TILBURY2

RESPONSE TO INTERESTED PARTIES' DEADLINE 7 SUBMISSIONS

TILBURY 2 DOCUMENT REF: PoTLL/T2/EX/231

Issued for end of Examination, 20 August 2018

A	07.08.18	MC	ADDITIONAL DETAIL ADDED	PH	PH
REV	DATE	BY	DESCRIPTION	CHK	APD
STATUS: FOR INFORMATION					
SCALE @ A3: AS SHOWN		CHECKED: PH		APPROVED: PH	
FILE REF: ITL11323		DRAWN: MC		DATE: 26.06.18	
DRAWING No: ITL11323-SK-048					
PROJECT No: ITL11323				REV: A

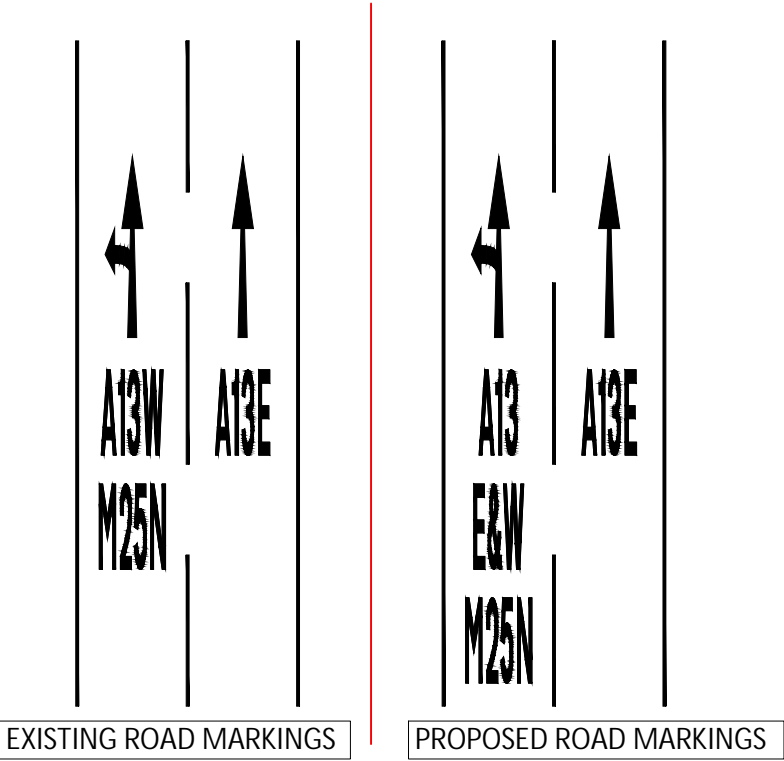
Further to the agreement with Highways England of the M25 Junction 30 works as shown on i-Transport drawings ITL11323-SK-048A and ITL11323-SK-051 which is reflected in the revised wording of draft DCO Requirement 7, please find below a breakdown of the expected costs of these works, based on our experience.
